US Nuclear Regulatory Commission

**Subject: Facility Response to 3/28/17 Request for Additional Information (Acc. # ML17038A272)**

On March 28<sup>th</sup>, 2017, the NRC sent a third Request for Additional Information (RAI) to the Kansas State University nuclear reactor facility (license R-88, docket 50-188) regarding a license amendment request (LAR) to add up to four 12%-loaded fuel elements to the core. The original LAR was submitted on April 9, 2012 (Acc. # ML1219A063).

Figure 1 - RELAP single channel model

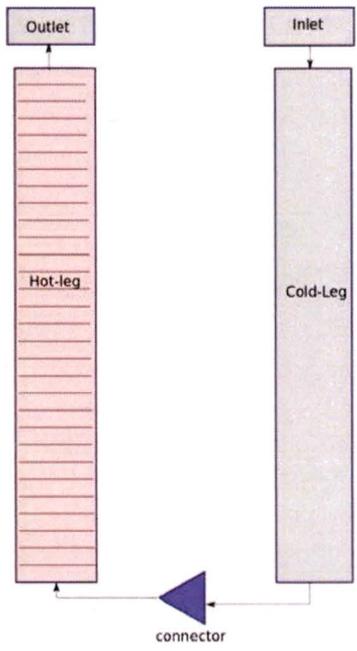
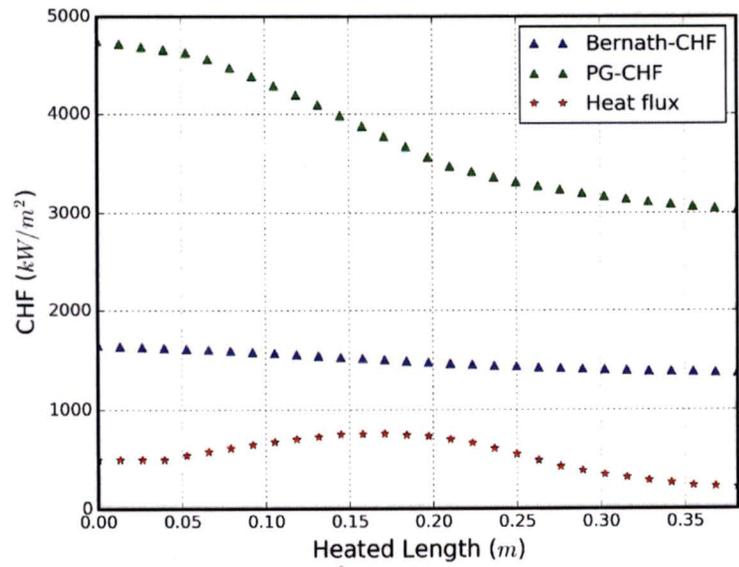
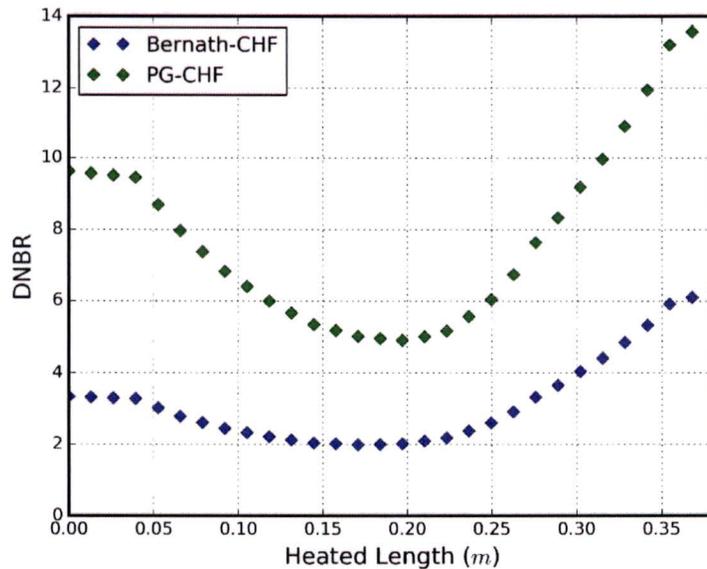
1. ... *Please provide information that validates the pool boiling model used in the SAR or alternatively provide a traditional hot channel analysis using the Bernath correlation...with core inlet conditions at the TS limit, or another correlation that has been validated against acceptable data.*

A RELAP-5 single-channel model was used to update the SAR analysis for a fuel element heated to 24 kWth in water at a pressure of 1.43 kPa, corresponding to the depth of the fuel in the reactor pool. 24 kWth is the power in a fuel element with an 85-element core operating at 1.25 MW and an element-to-average power peaking value of 1.63. The bulk water temperature used in the analysis was 49°C. This value is slightly lower than the maximum of 54°C specified in the Technical Specifications. However, based on this analysis, the TS will be revised to permit a maximum bulk water temperature of 44°C in order to avoid bulk boiling of the coolant.

The departure from nucleate boiling ratio (DNBR) reached a minimum value of slightly above 2.0. This is significantly lower than the DNBR calculated in the current version of the SAR. The reactor core grid plates contain an array of 8 mm interstitial holes meant to accommodate flux wires or other experiments. The presence of an experiment in these holes may reduce the temperature at which bulk boiling will occur; therefore an additional experimental design constraint is being proposed for the TS that forbids the insertion of tubes or flux wires in the interstitial holes at bulk water temperatures

greater than 37°C. A drawing of the upper grid plate showing the interstitial holes is attached for reference.

Figure 4 -Power peaking map with different control rods stuck in, with a 12% element in location E-10 and a maximum core power of 1.25 MW.

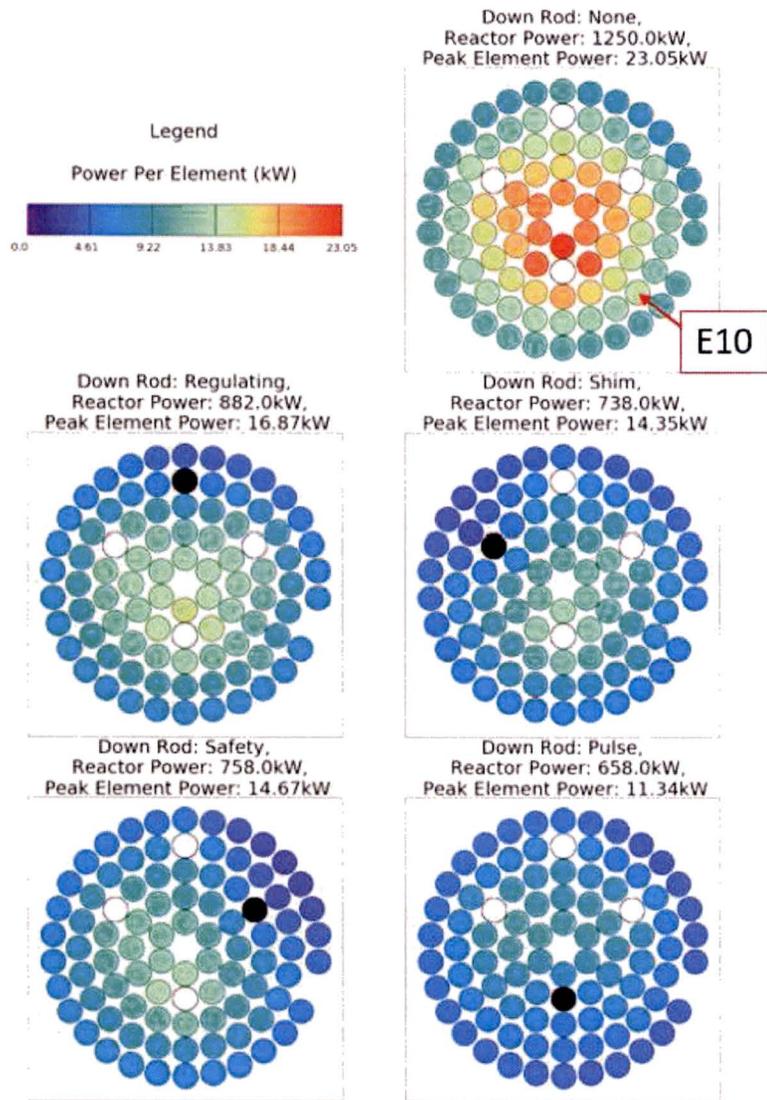
5. ... If operation with one or more control rods inoperable but fully inserted is acceptable, please provide the supporting analyses and evaluations from which operational acceptability is derived.

A similar study was conducted using a peak power of 1250 kWth with all rods withdrawn, but with a single 12.3%-weighted fuel element in location E-10. This study confirms that the maximum power in a single fuel element remains well below the SAR-assumed value of 2.0 element-to-average, even with a high-load fuel element on the opposite side of the core relative to the inserted control rod. The results are depicted in Figure 4.

Therefore the case of an inoperable control rod being fully inserted may slightly increase maximum power peaking but will greatly reduce the maximum power per element. The slight increase in power peaking will also be more than offset by the reduction in core reactivity due to the insertion of the rod poison, resulting in a massive decrease to the maximum fuel element power.
